# CITY PLAN COMMISSION STAFF REPORT

June 4, 2025

## Lineage Connect UR Redevelopment Project Name

CD-CPC-2025-00039  
Urban Redevelopment District

PRELIMINARY LANDSCAPING PLAN

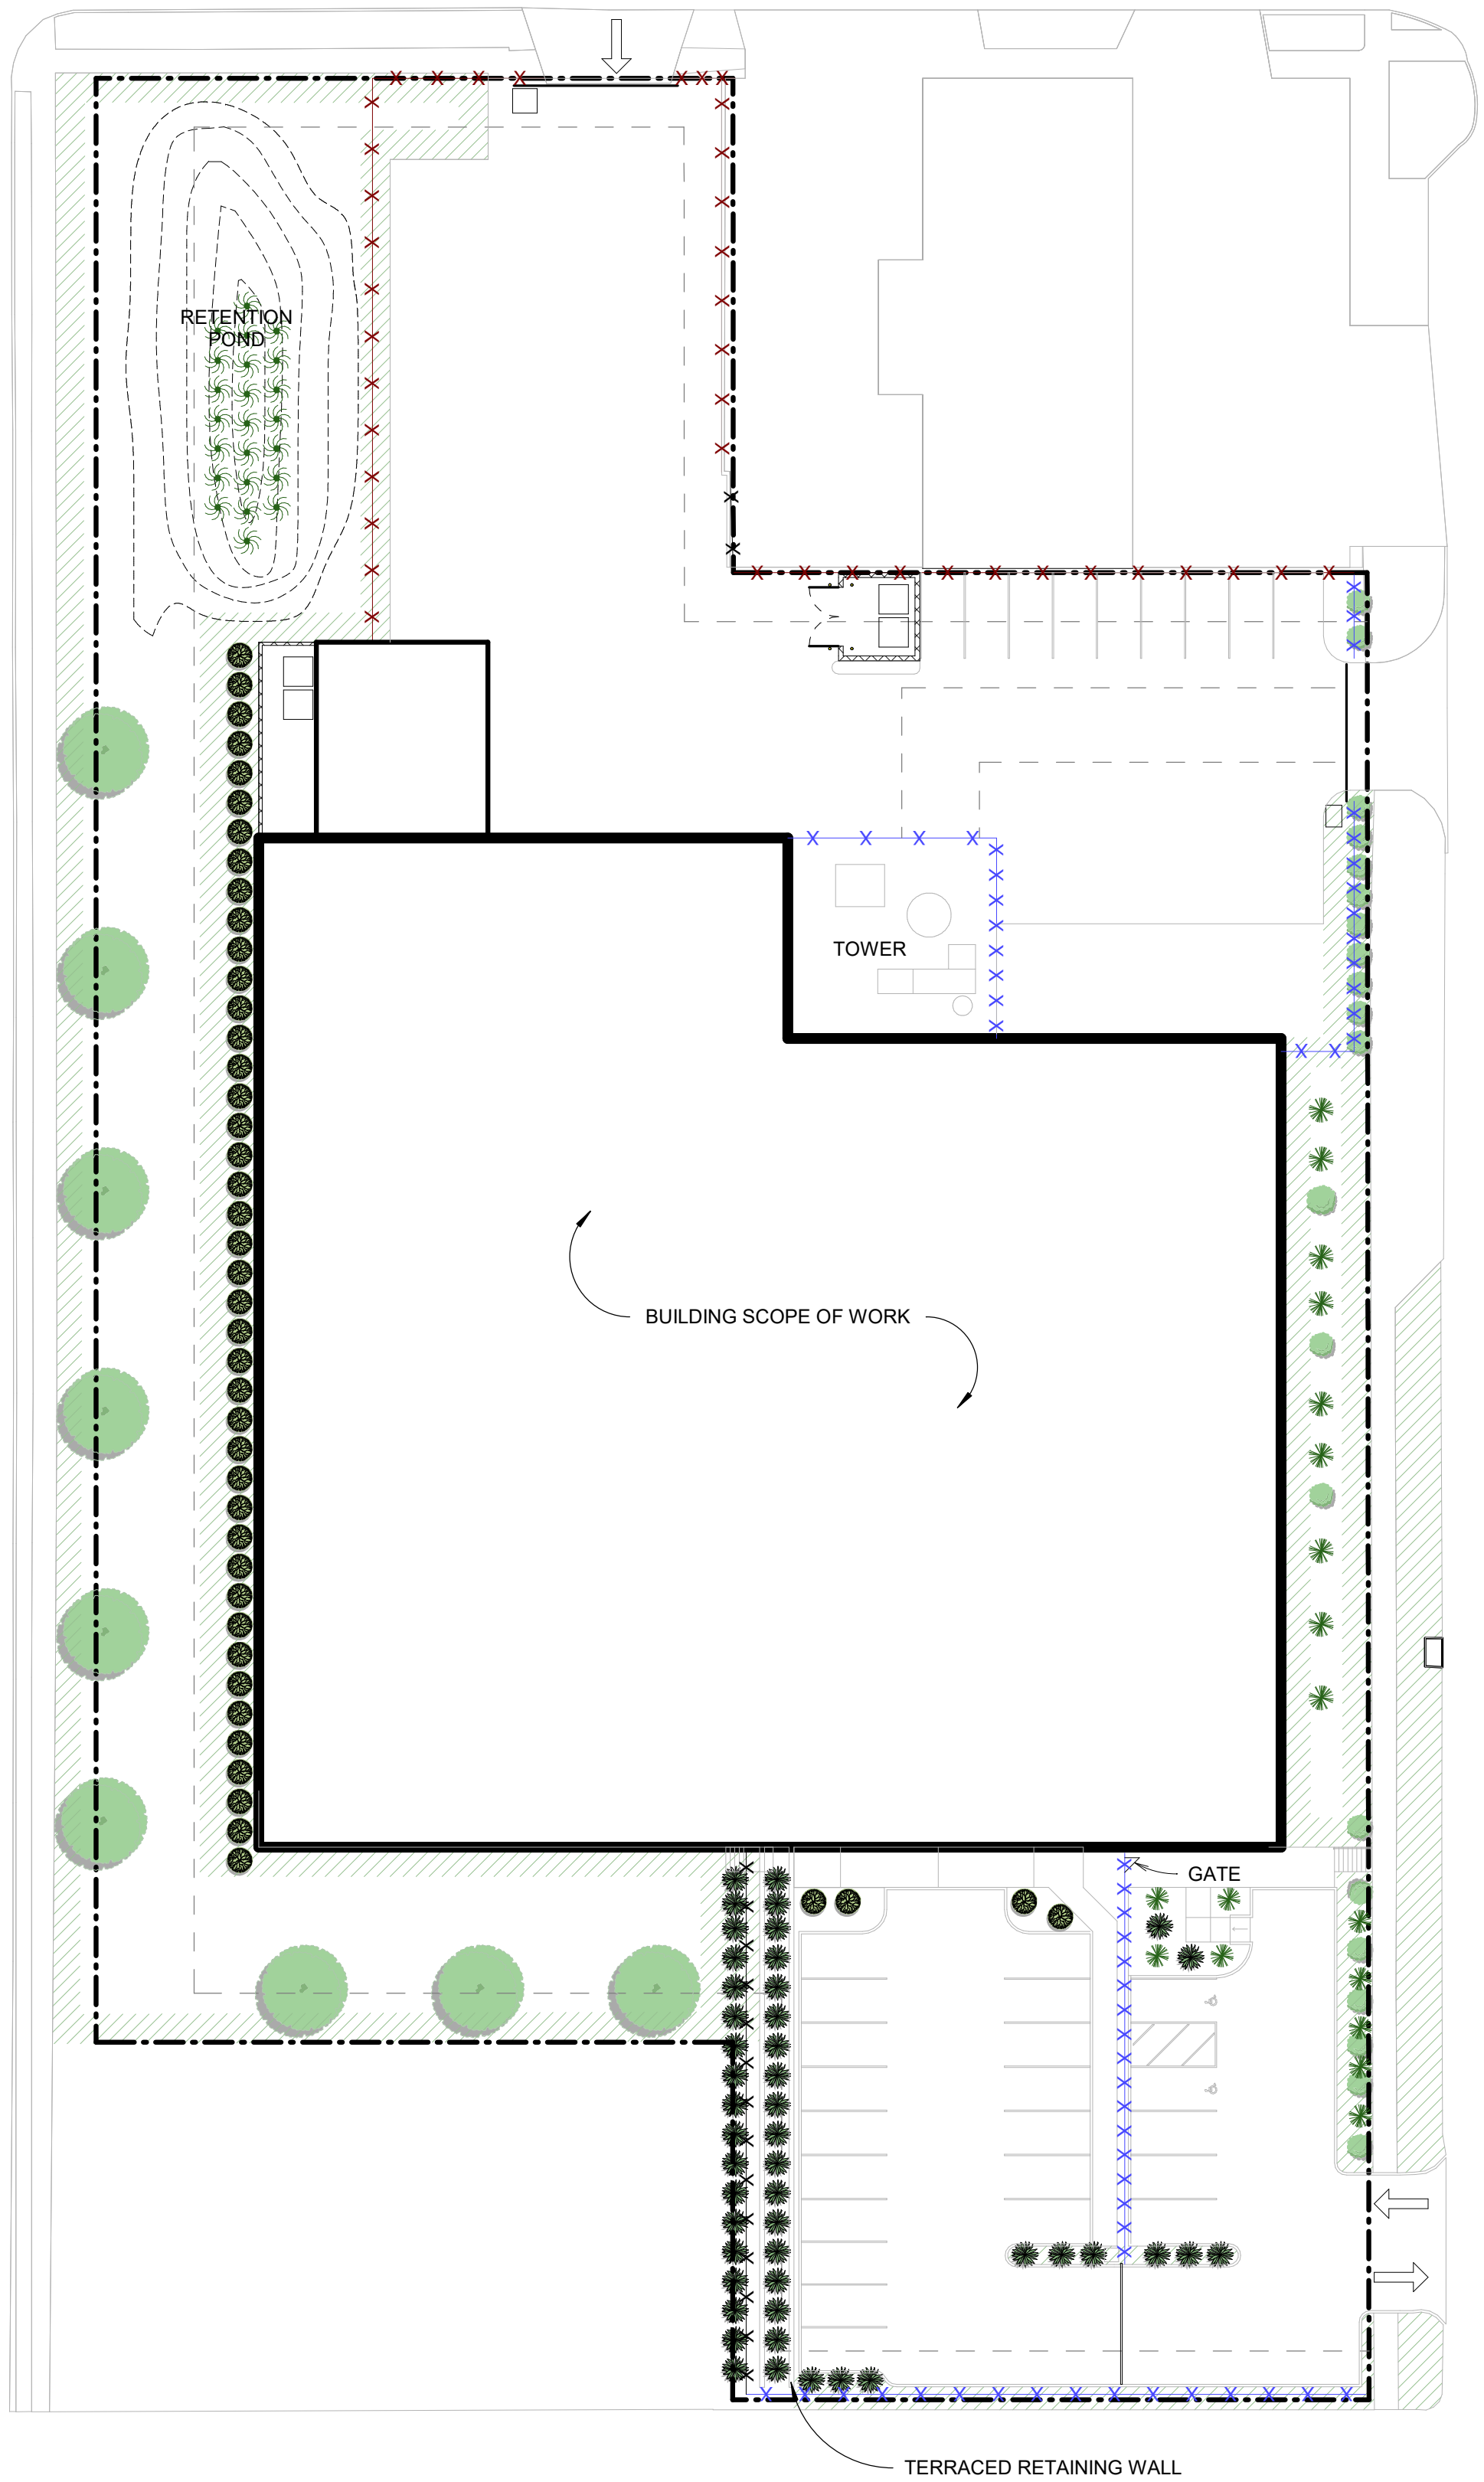
11. That the UR Final Plan must include a landscape plan which shows landscape species with at least 90% of which are native to Missouri as determined by the Missouri Botanical Gardens.

19. Provide location and species of proposed street trees along Prospect Avenue that meet any applicable standards of the City Forester and the Public Works Department in the final UR Plan.

MITIGATION PLAN  
1" = 30'-0"

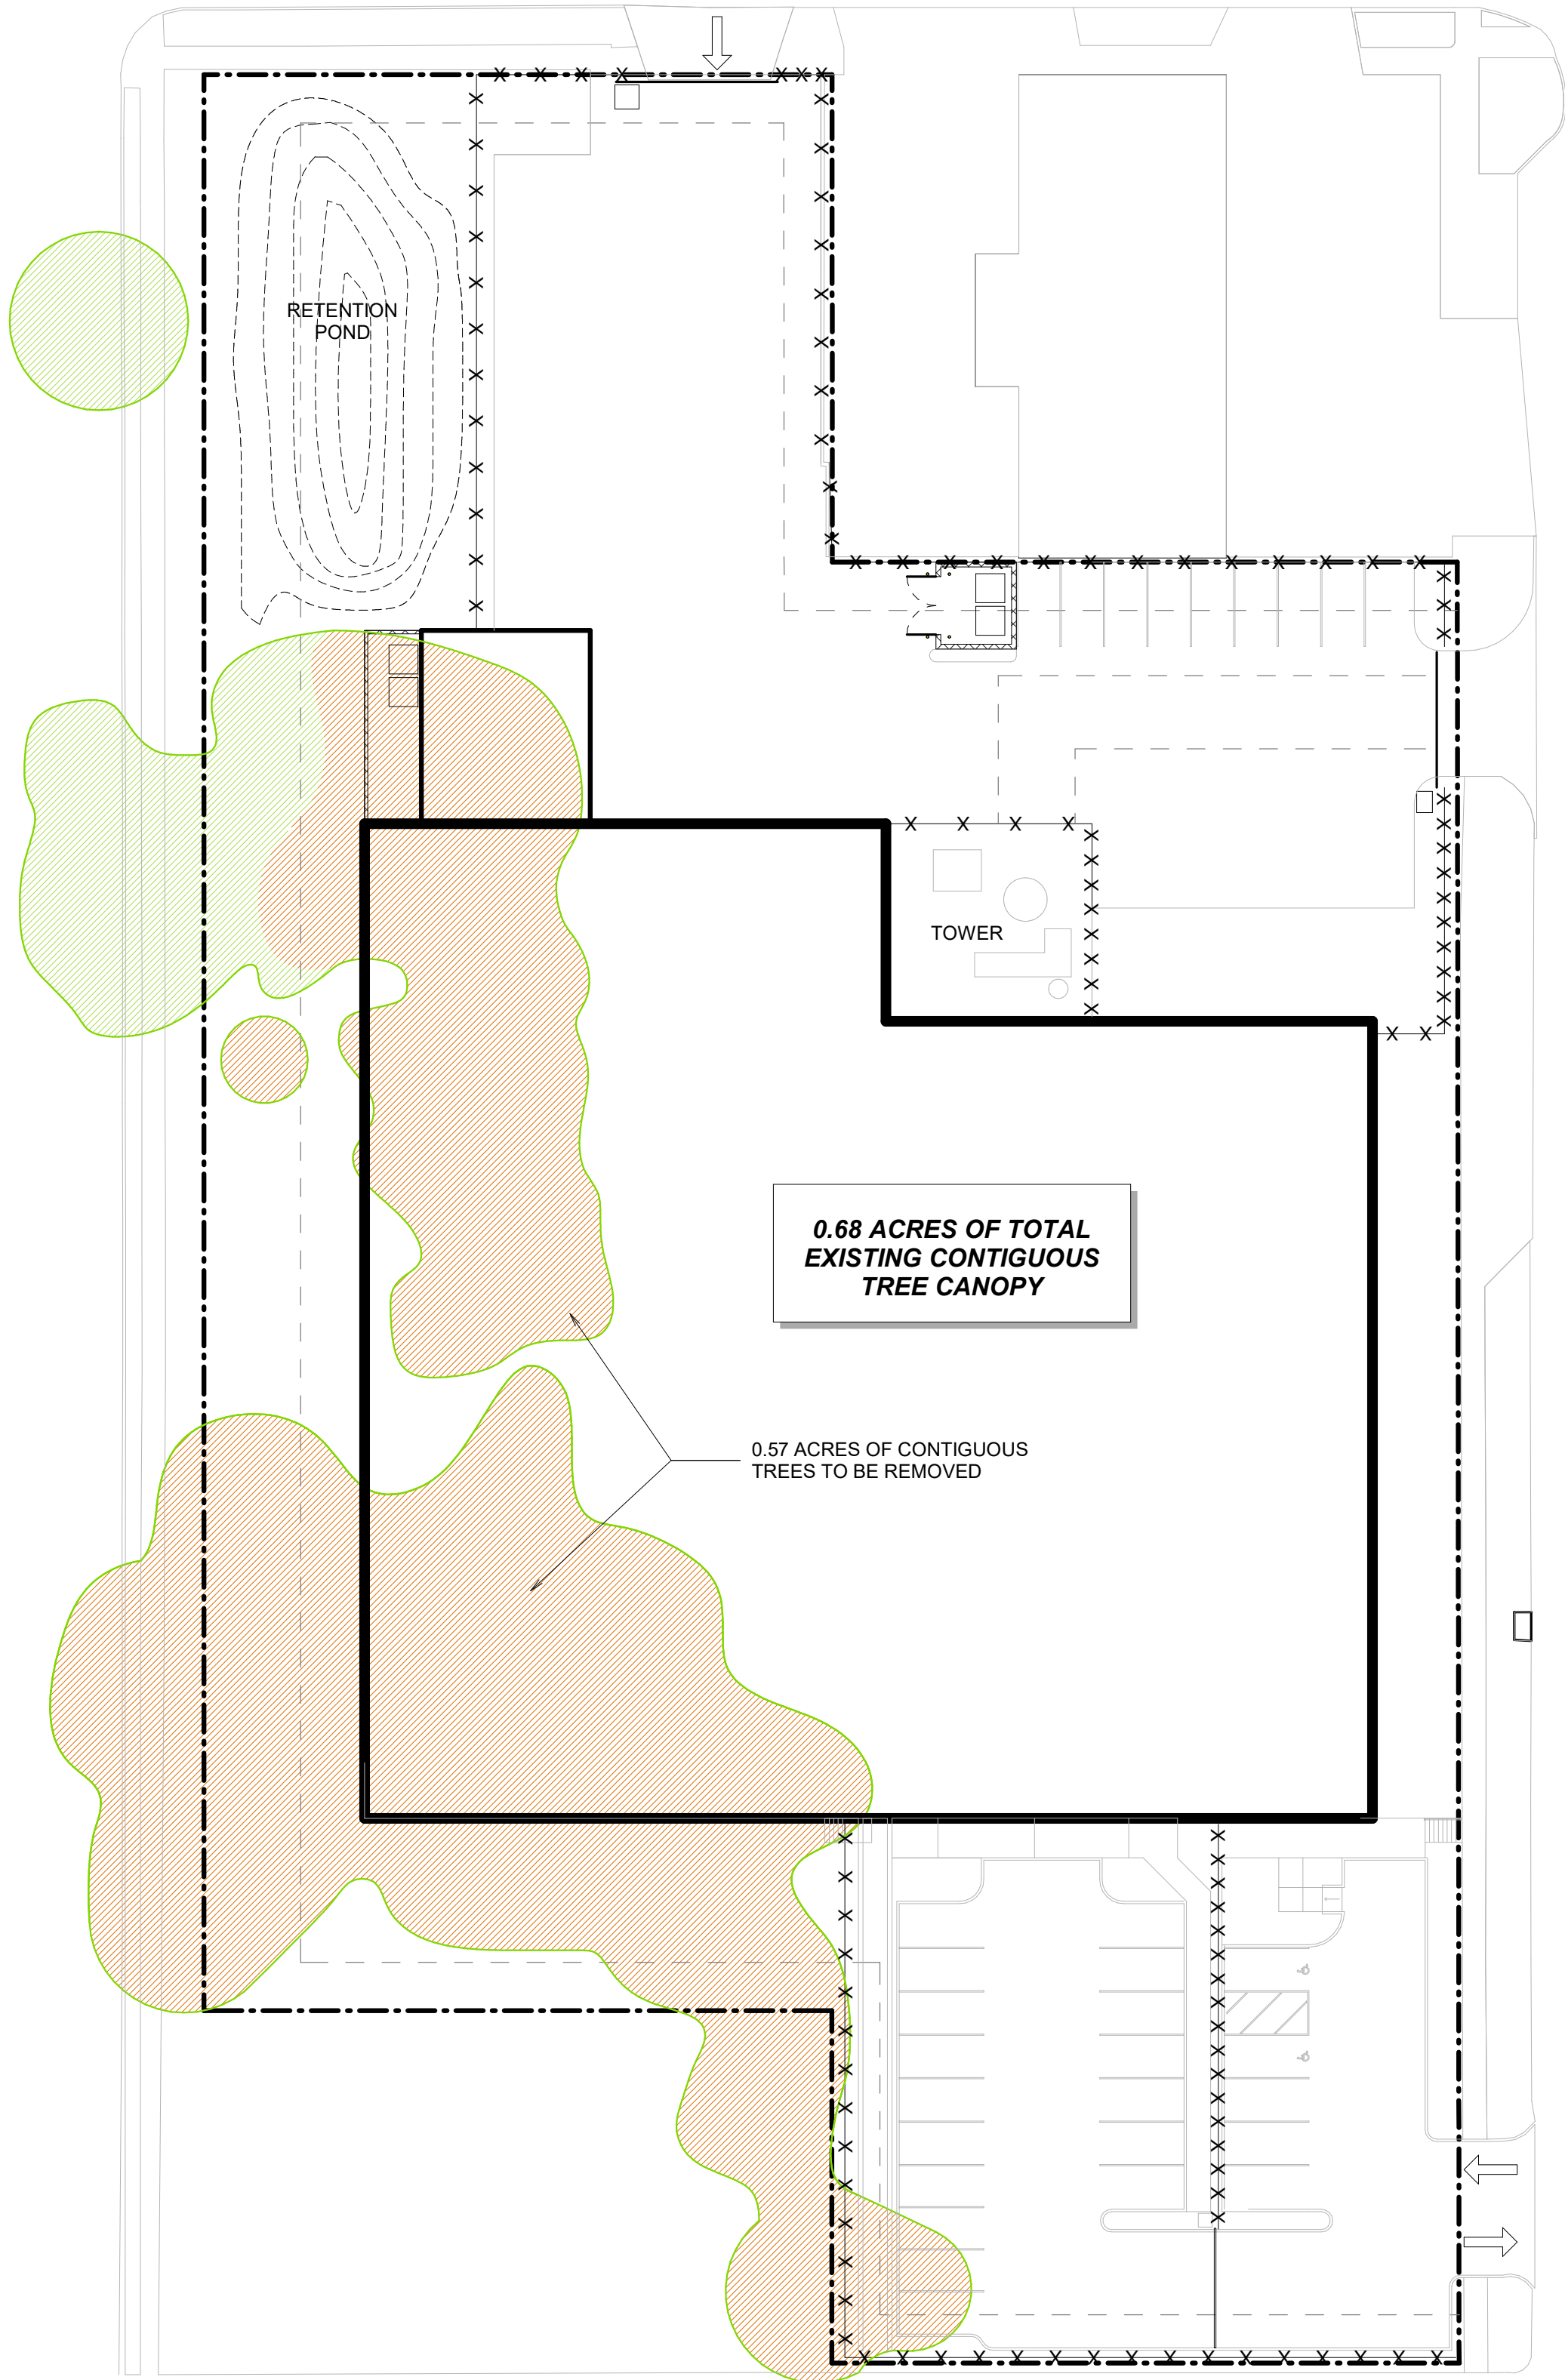
The plan identifies trees to remain and new trees to be planted. Preservation plan did not identify over 1 acre of existing mature canopy.
